City of Seattle

STANDARD SYMBOLS
SEWER & DRAINAGE

MONUMENT FRAME & COVER

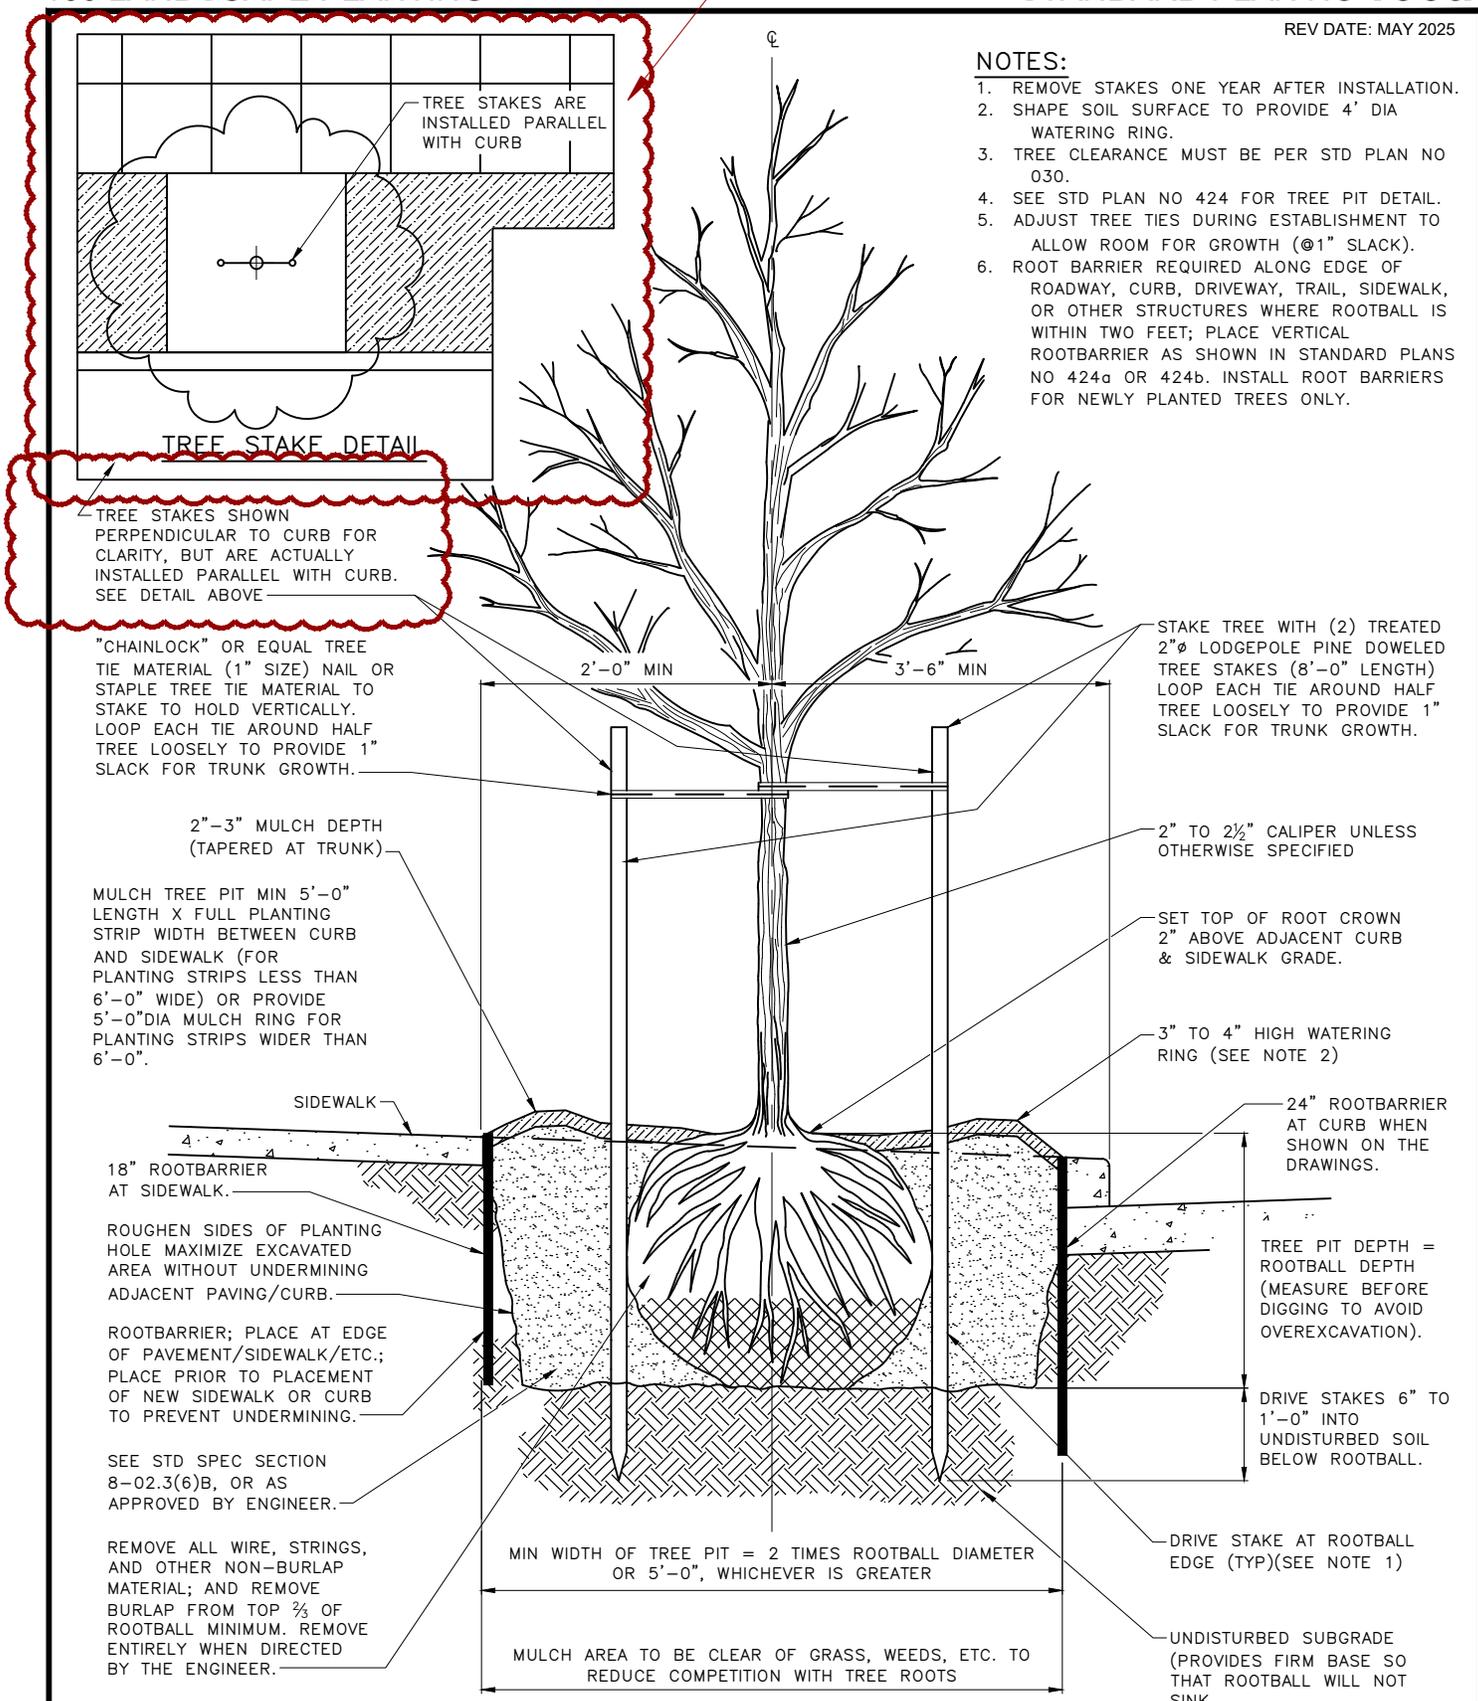
"SHALL" changed to "MUST"

*new detail
& callout*

IRRIGATION POINT OF CONNECTION DIAGRAM

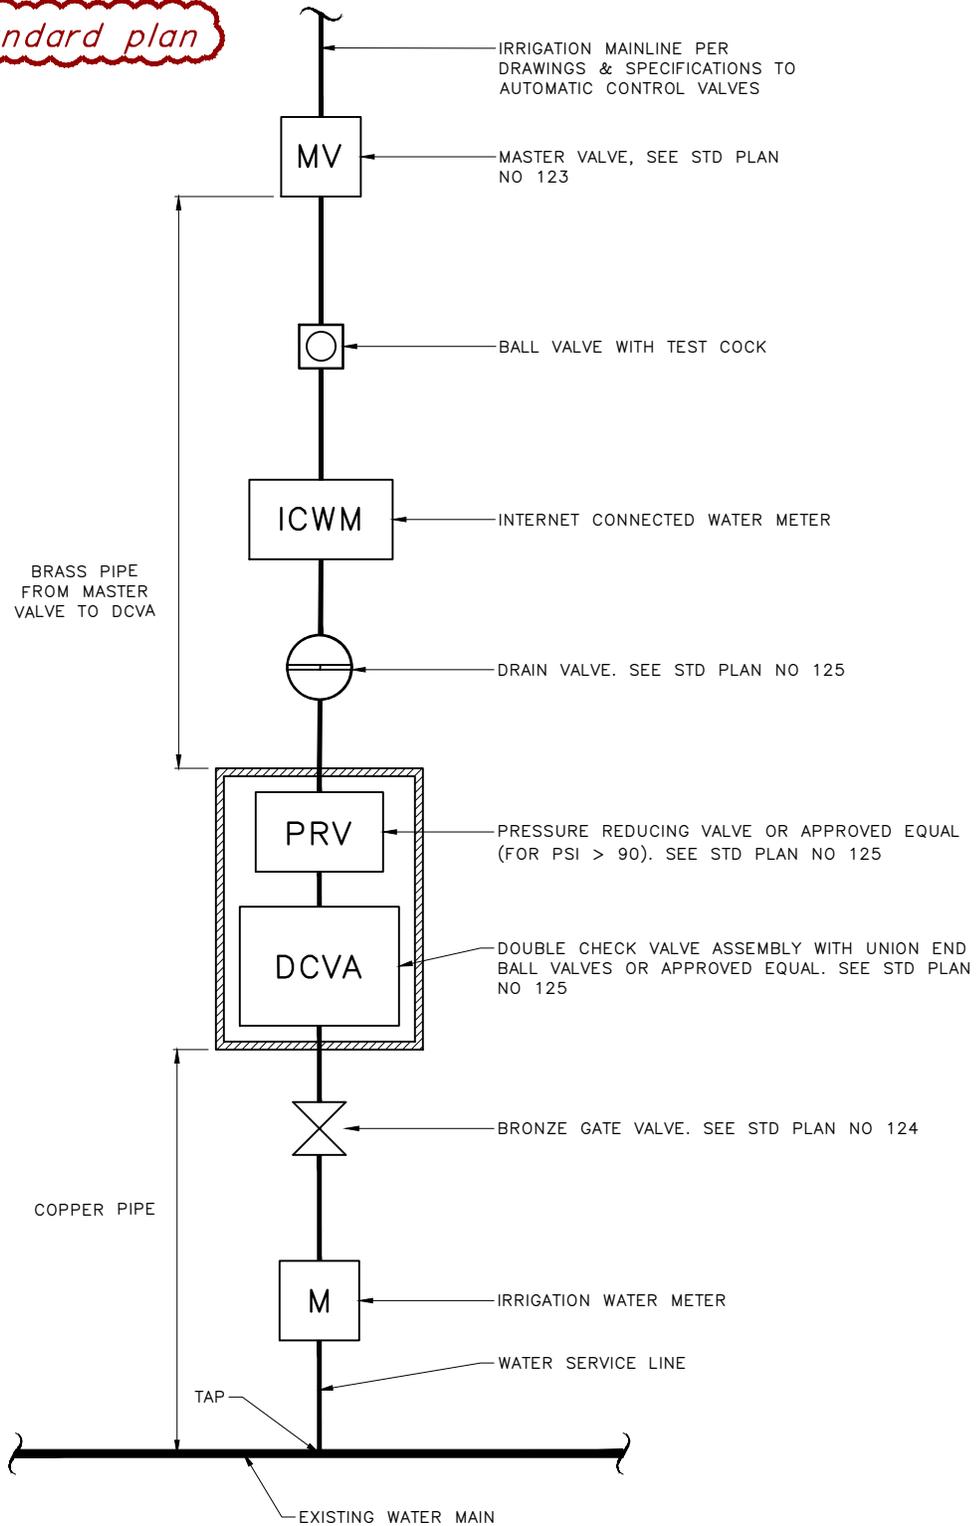
new standard plan

IRRIGATION POINT OF CONNECTION
DIAGRAM FOR BATTERY
OPERATED CONTROLLERS

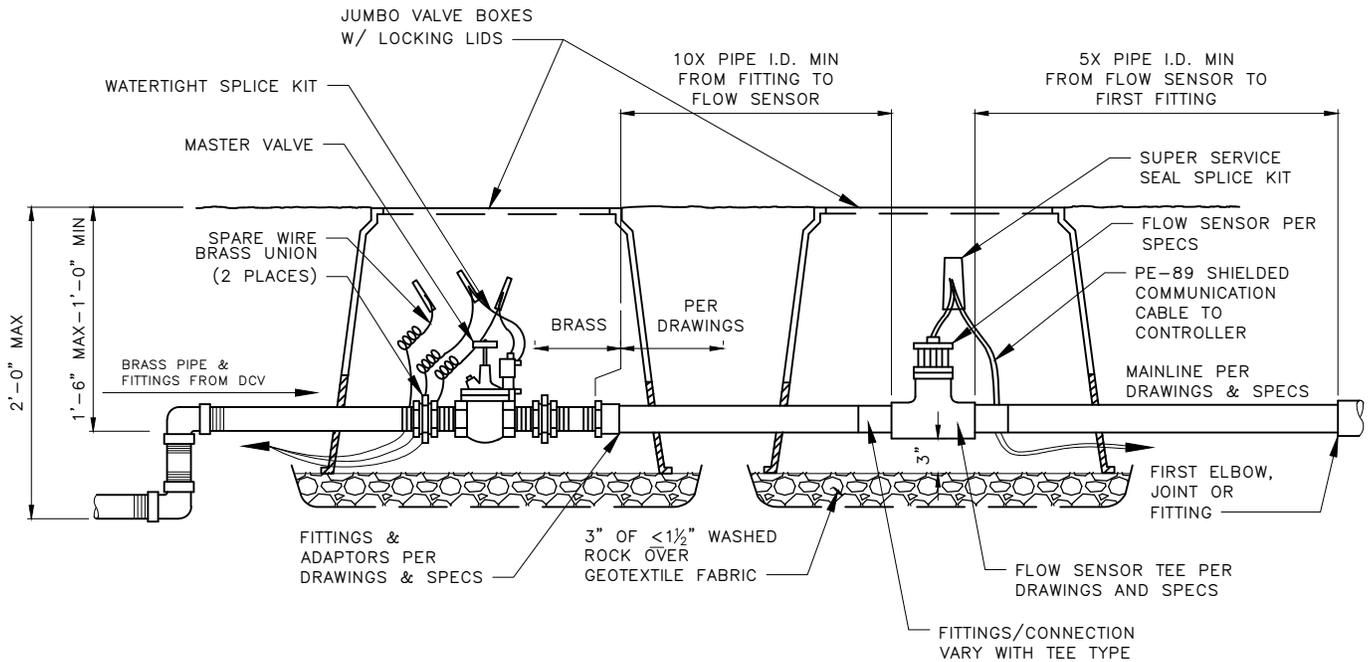
new standard plan

IRRIGATION HOSE BIB ASSEMBLY AND QUICK COUPLER VALVE

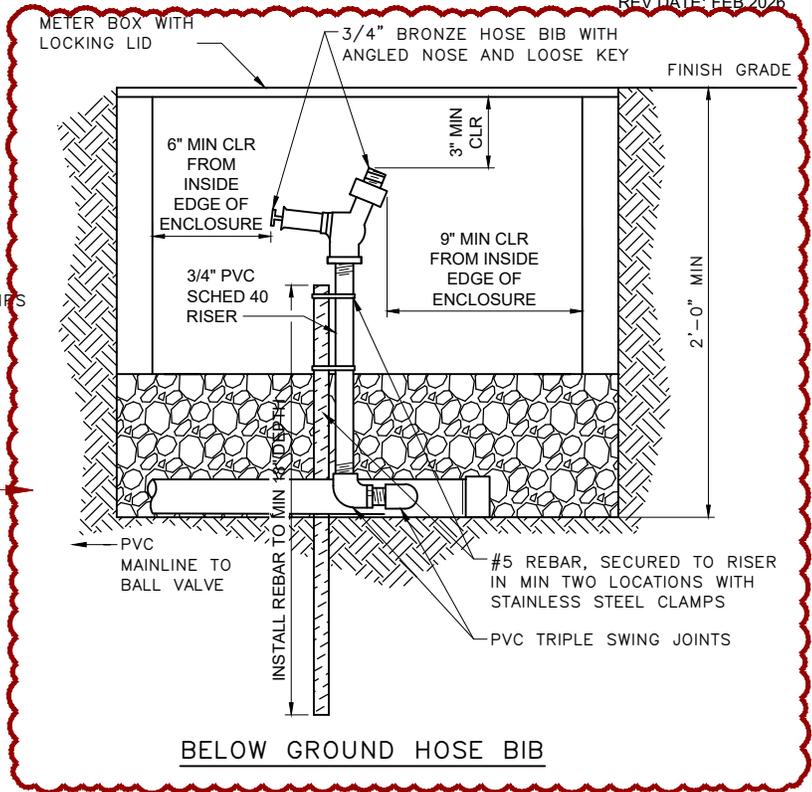
"PVC GALVANIZED" changed to "BRASS"

**POP UP & FIXED
IRRIGATION HEADS**

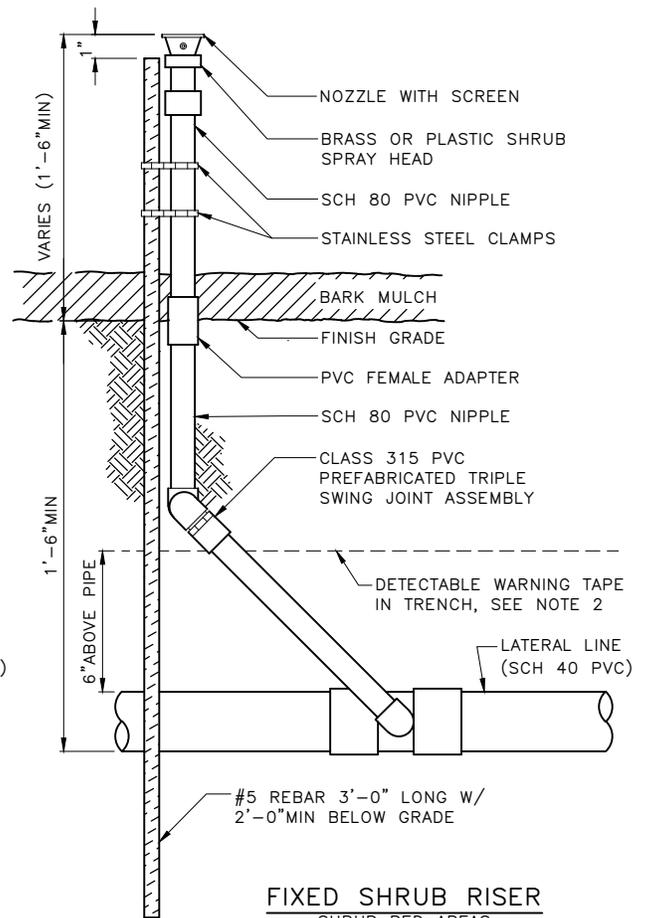
"MAX" changed to "MIN"

IRRIGATION SLEEVE TRENCHING UNDER PATHWAY OR SIDEWALK

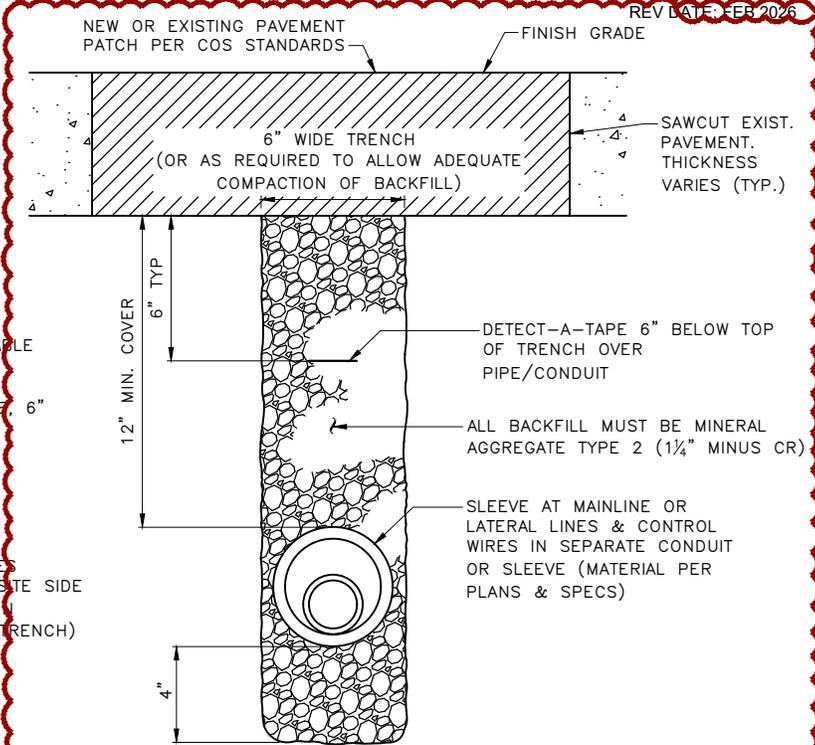
detail revised

notes revised

IRRIGATION TRENCHES

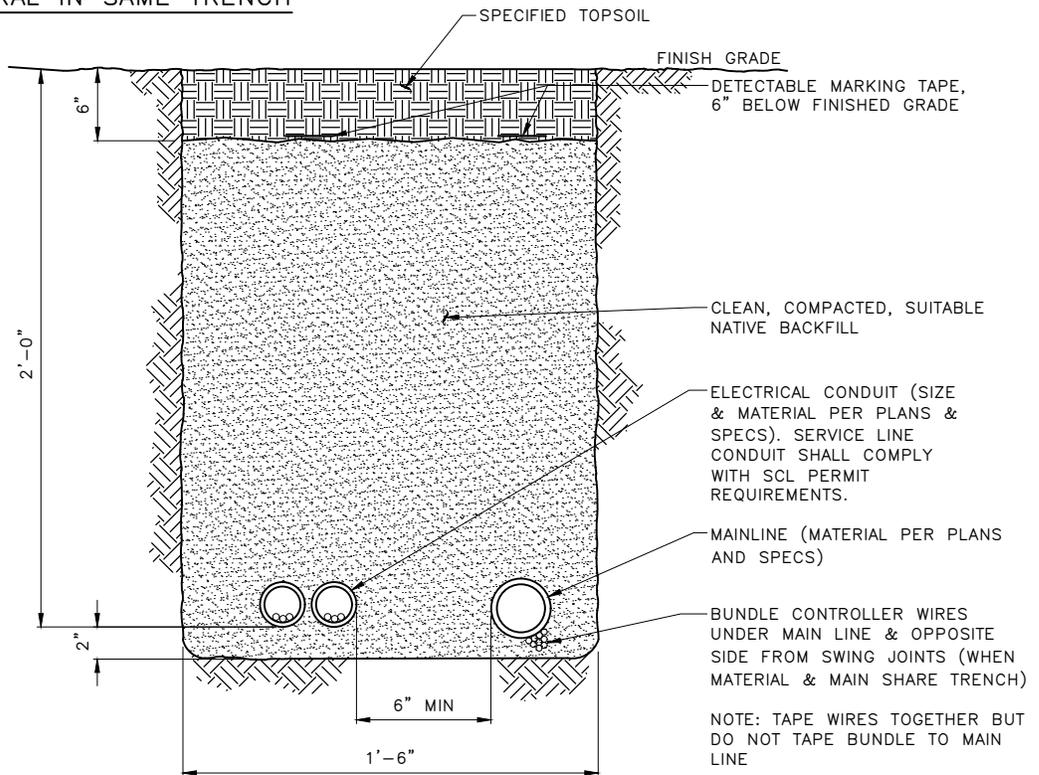
new standard plan

INSIDE DROP CONNECTION

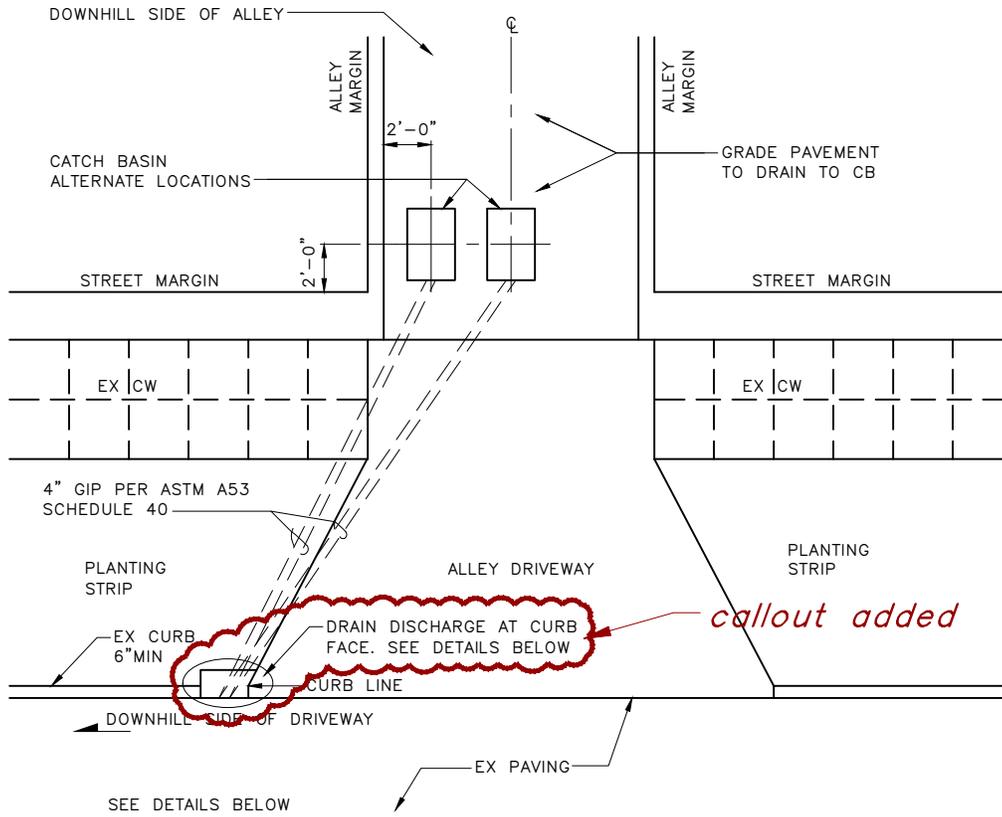
"STAINLESS STEEL BLIND FLANGE & BOLTS" changed to "DIP PLUG & STAINLESS STEEL BOLTS"

INLET FRAME & GRATE

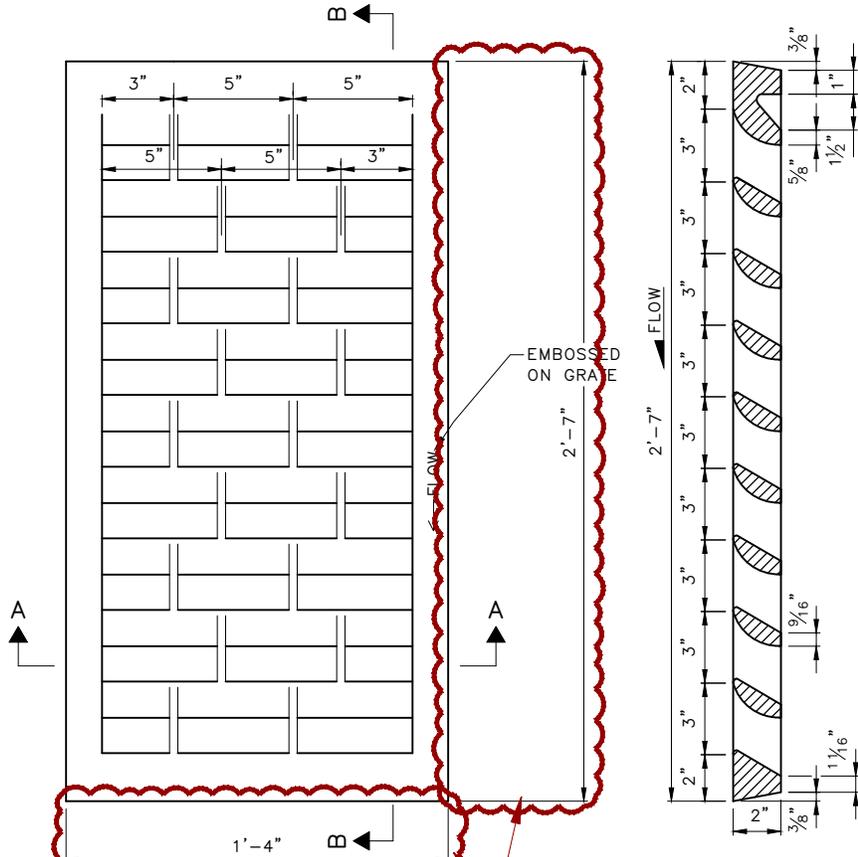
Spec Sec 9-12.7(2) added

dimensions added

TYPICAL DRAIN CURB CUT LOCATION FOR BIORETENTION WITH SLOPED SIDES

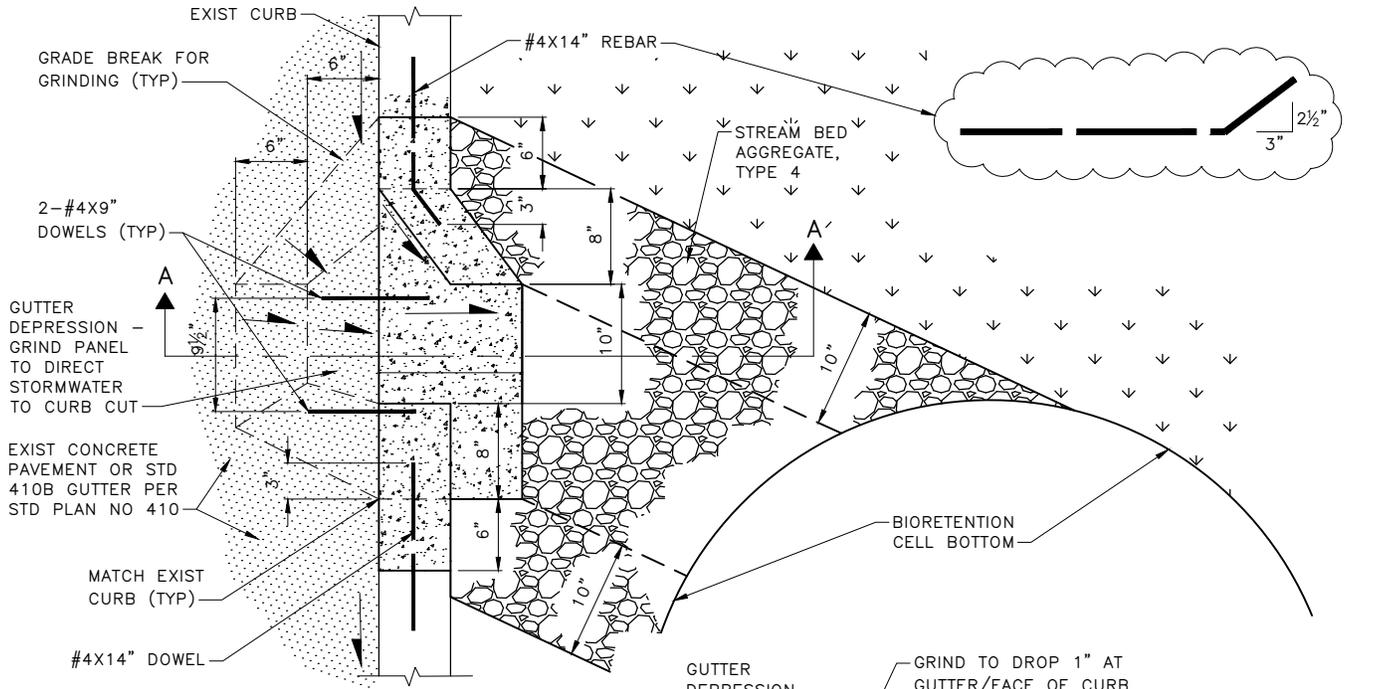
"8-04" added

CAST IRON VALVE BOX &
OPERATING NUT EXTENSION

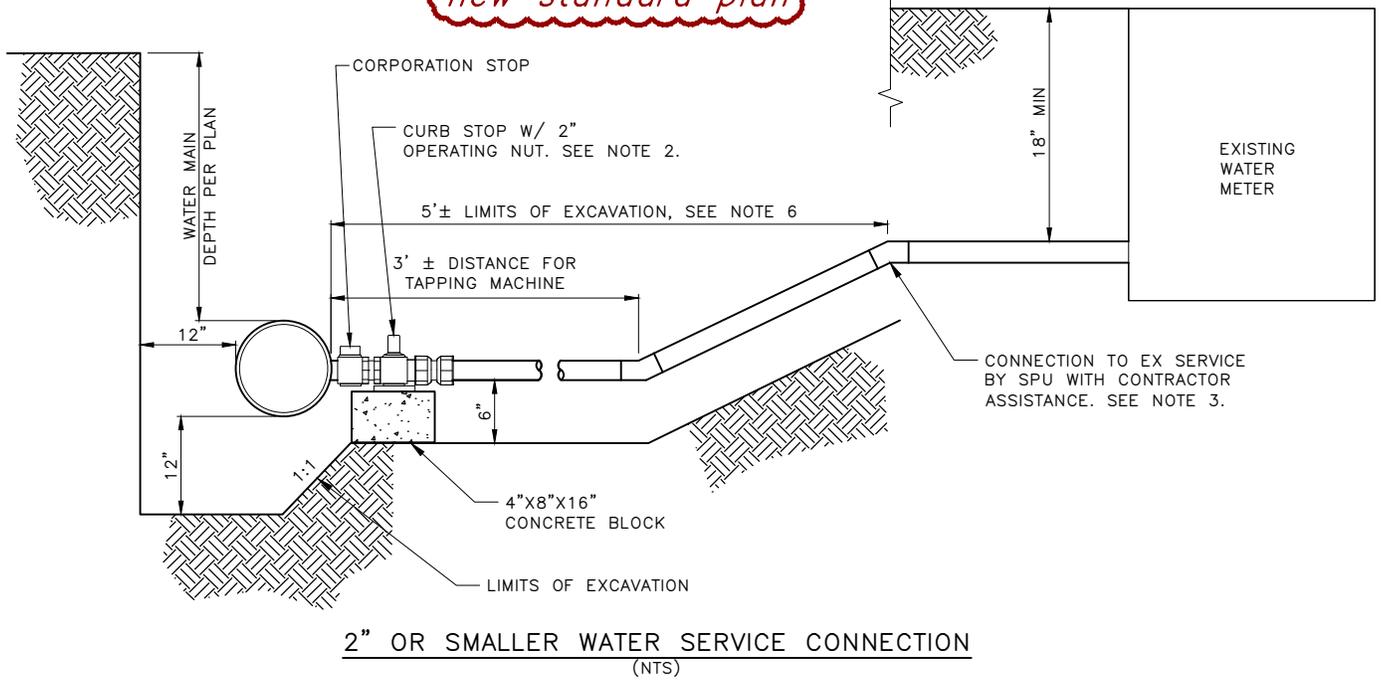
*previous note
2 removed*

new standard plan

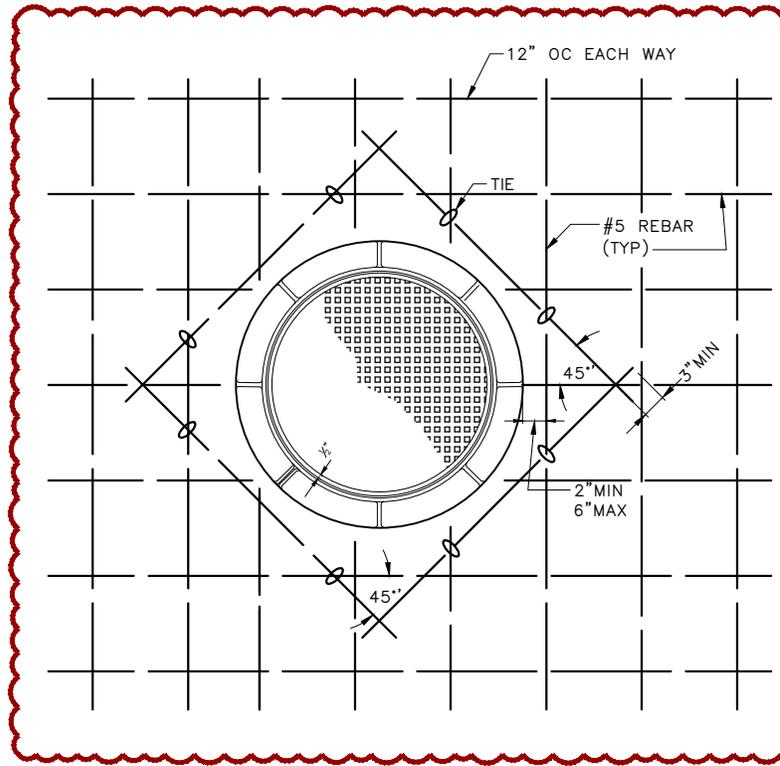
added

"W2.9" revised to "W4.0"
